Subject: WPPSS NUCLEAR PROJECT NO. 2
RESPONSE TO QUESTIONS
SACRIFICIAL SHIELD WALL DESIGN

Reference: Letter, W.R. Butler to J.J. Stein, transmitting Request
for Additional Information dated July 8, 1974. (GI2-74-11)

SACRIFICIAL SHIELD WALL DESIGN SUPPLEMENTAL INFORMATION

WPPSS 74-2-R2-ATABLE OF CONTENTS

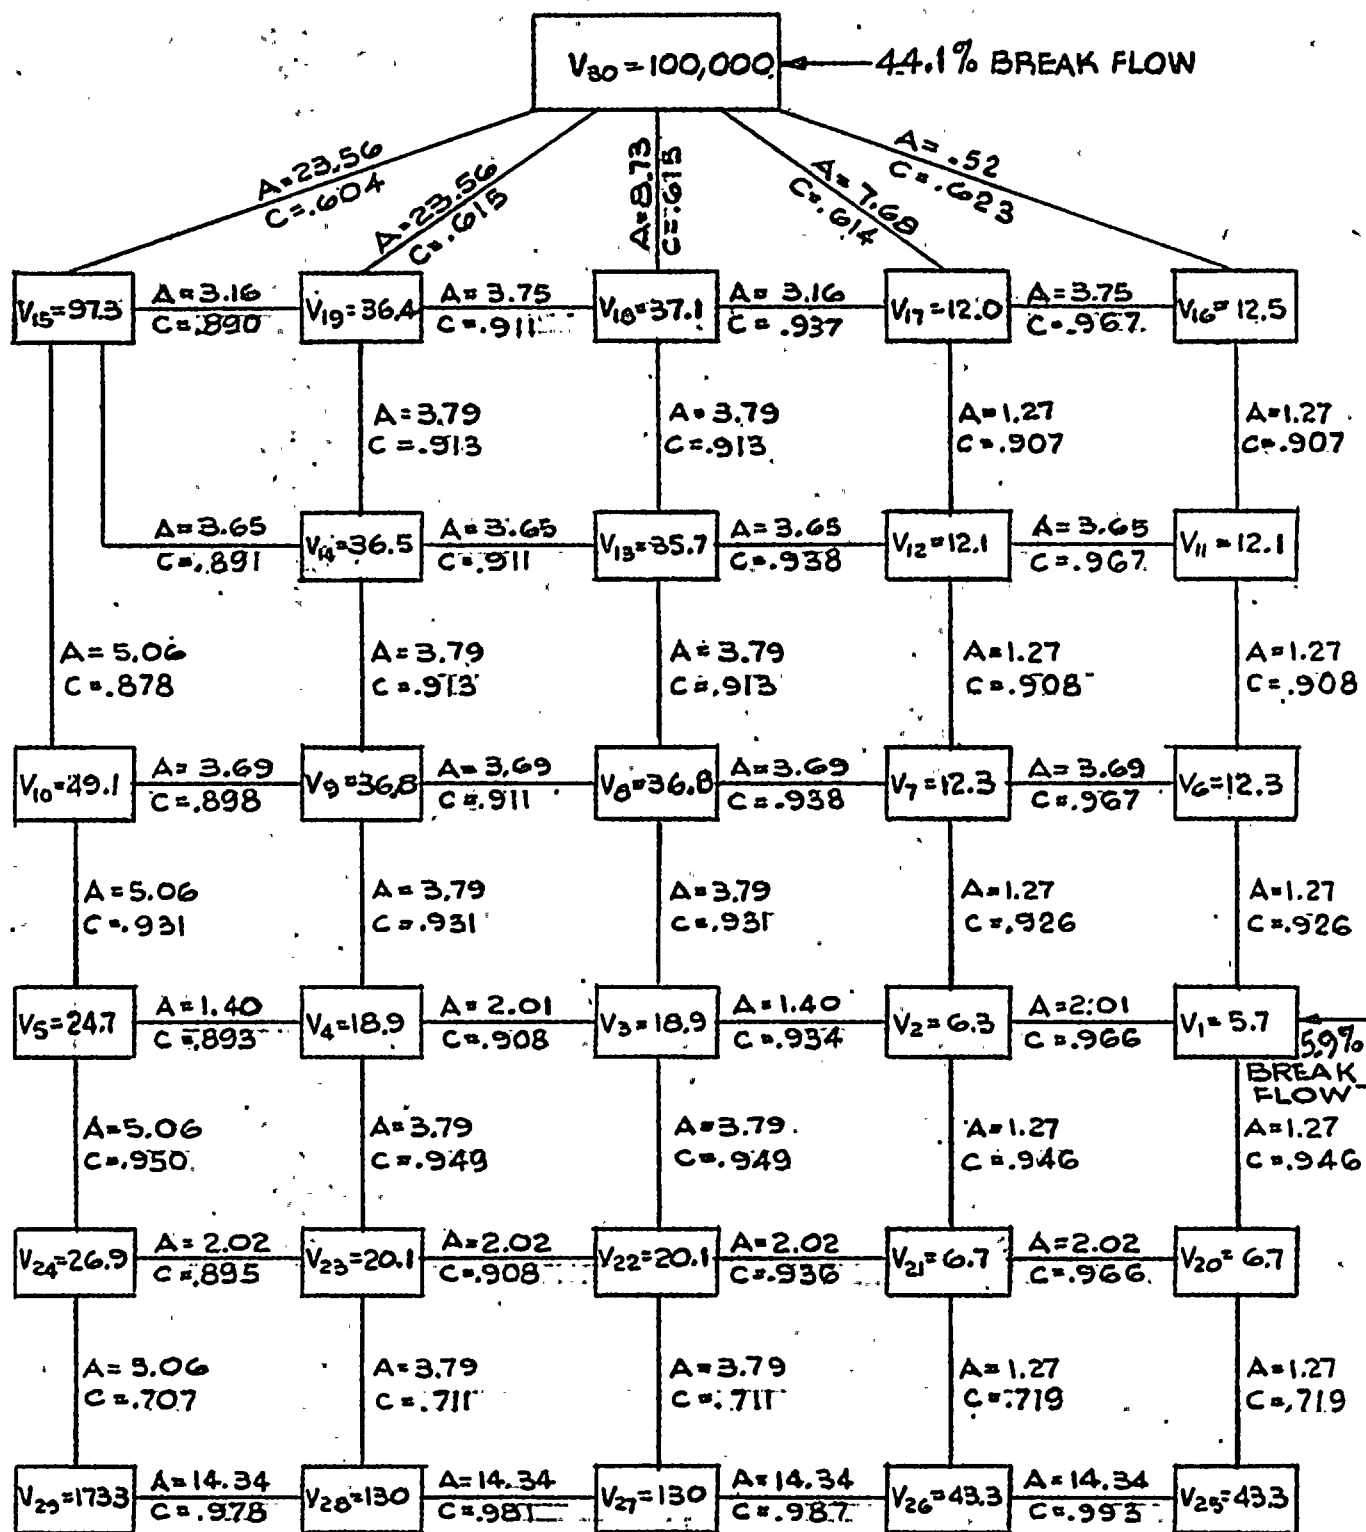
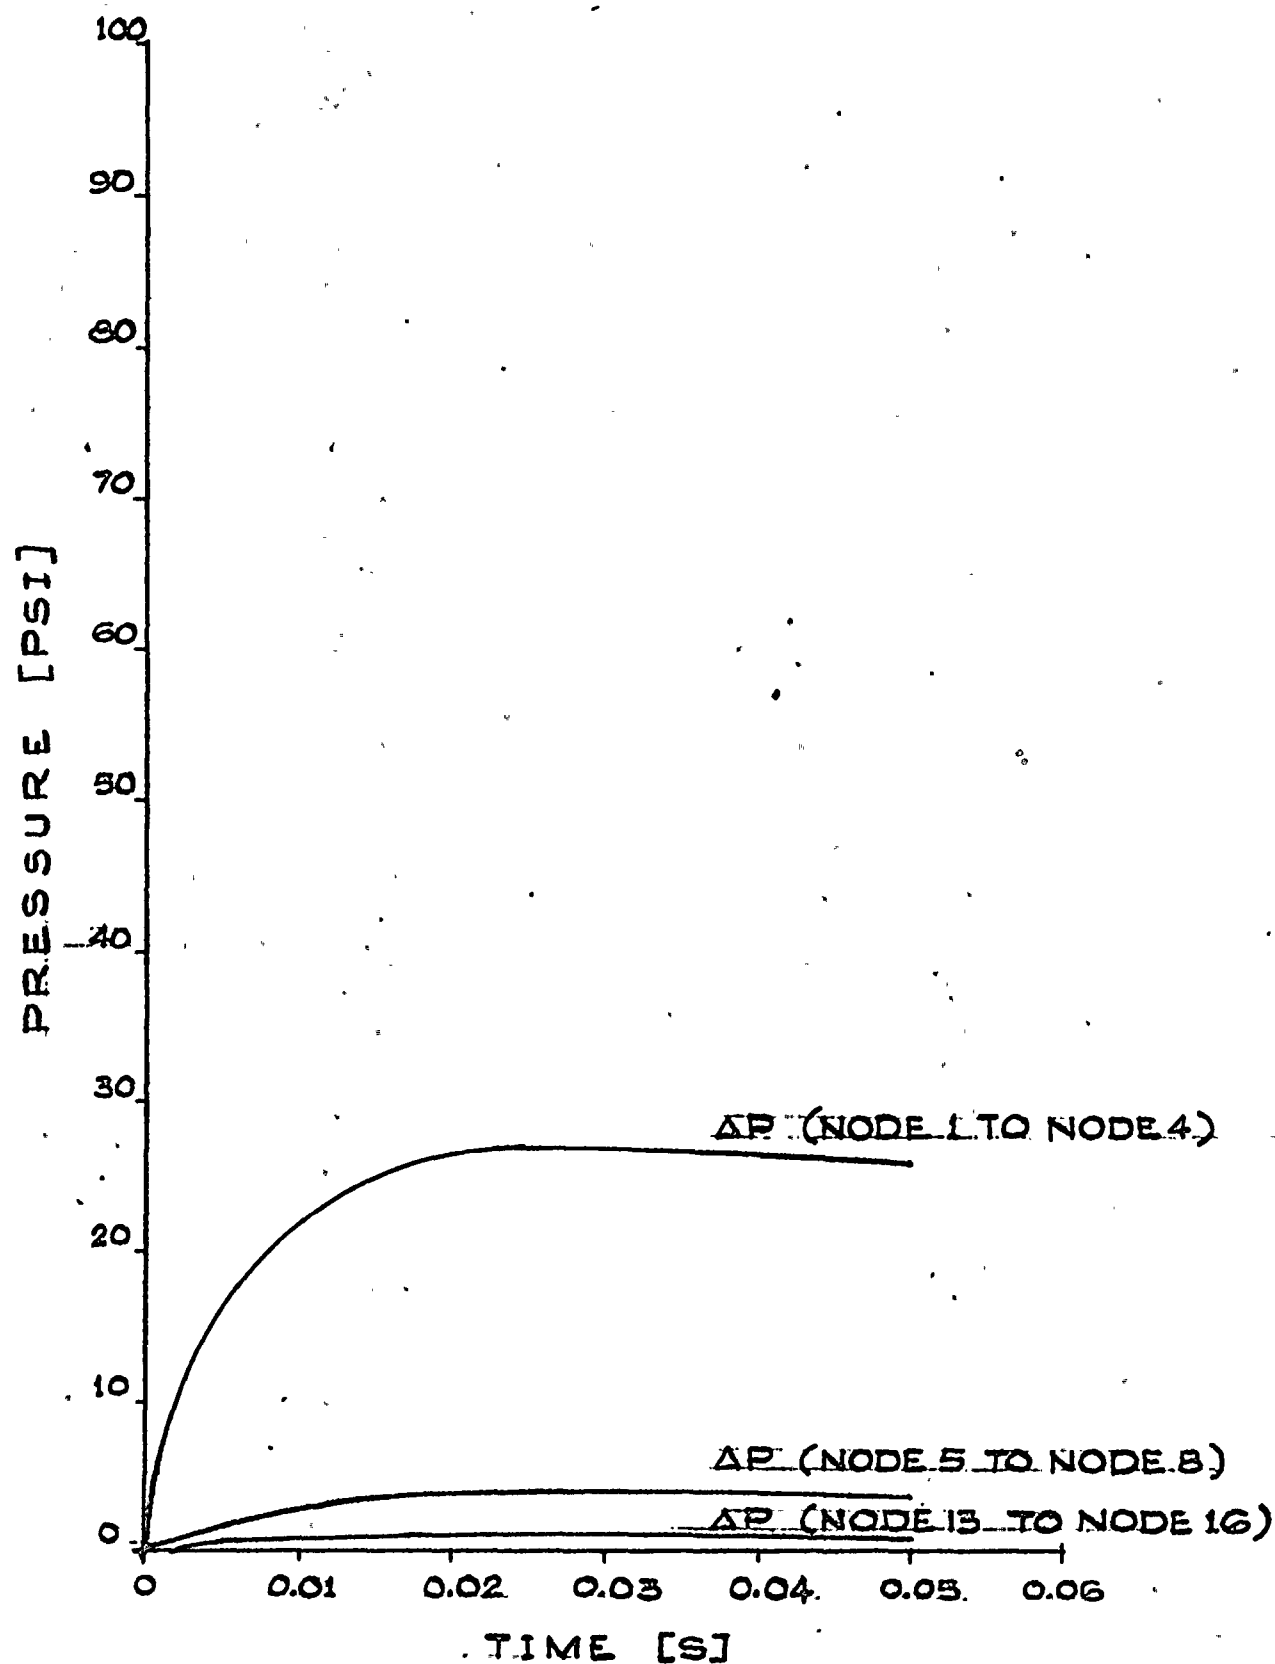
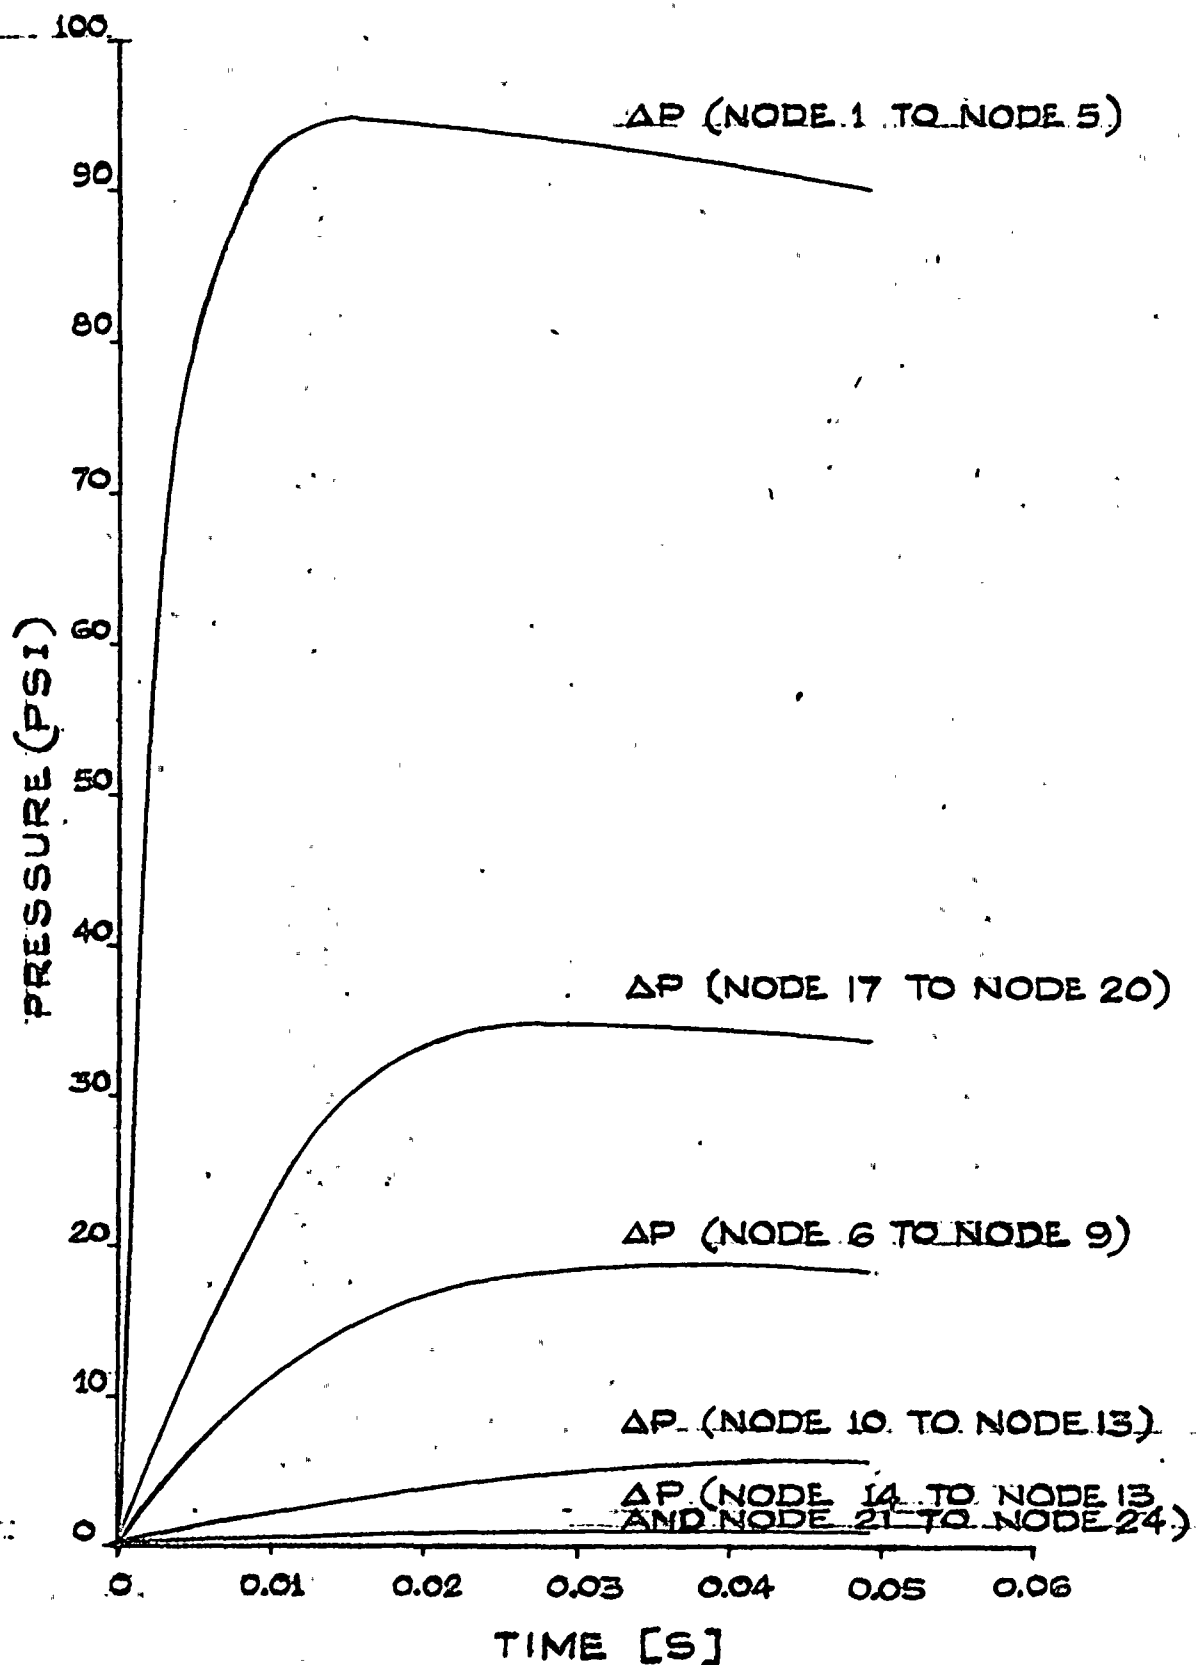
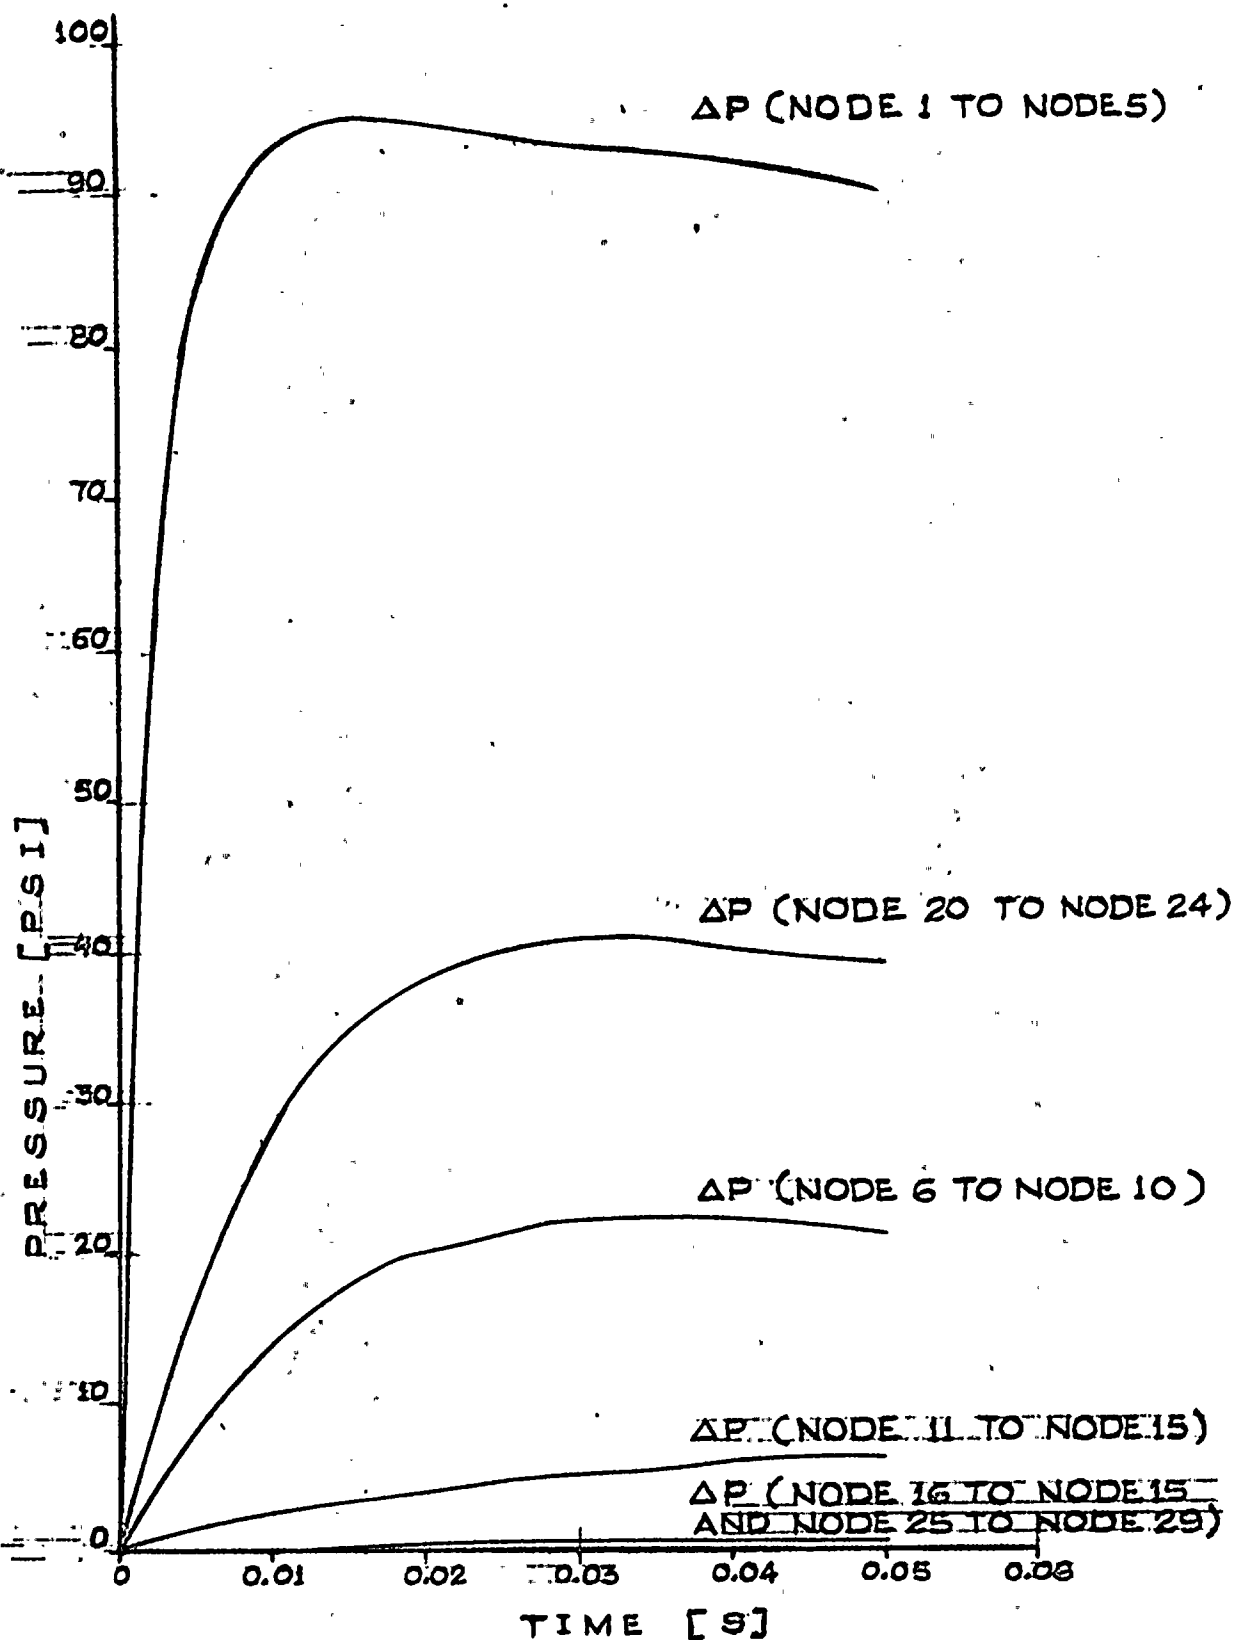
Provide a schematic flow diagram showing the nodalization of the shield annulus and specifying nodal net free volumes and interconnecting flow path areas.

Provide and justify values of vent loss coefficients and/or friction factors used to calculate flow between nodal volumes. When a loss coefficient consists of more than one component (e.g., entrance loss, exit loss) identify each component and its value.

Schematic flow diagrams for the 3 cases discussed in Question 2d are given in Figures 16, 17, and 18. Flow coefficients are also shown for vent areas.

Flow coefficients between nodal volume are shown in the schematic flow diagrams, Figures 16, 17, and 18. The equation used to establish the flow coefficient between nodal volumes is discussed in the response to question 1a (See equation 8).

Within the annulus, for example between node 8 and node 9, the friction loss coefficient is used to establish the flow coefficient since no contraction or expansion loss occurs. The friction loss coefficient is determined from reference 3 based on the hydraulic diameter between nodes and the path length from the center of one node to the center of the adjacent node.

From the annulus to the drywell (e.g., node 18 to node 30 in the 60 node case) the flow coefficient will consist of three terms - an expansion loss coefficient, a contraction loss coefficient, and a friction loss coefficient. The expansion loss coefficient and the contraction loss coefficient are conservatively taken as 1.0 and 0.5 respectively as given in reference 3. The friction loss coefficient is determined from reference 3 based on the hydraulic diameter of the node in the annulus (e.g. node 18) and the path length from the center of the node in the annulus (e.g. node 18) to the drywell.

For flow across elevation 527' (e.g., node 22 to node 27 in the 60 node case), the flow coefficient will consist of two terms - an expansion loss coefficient and a friction loss coefficient. The expansion loss coefficient is a function of the hydraulic diameters as given in reference 3 for a sudden enlargement. The friction loss coefficient is determined from reference 3.
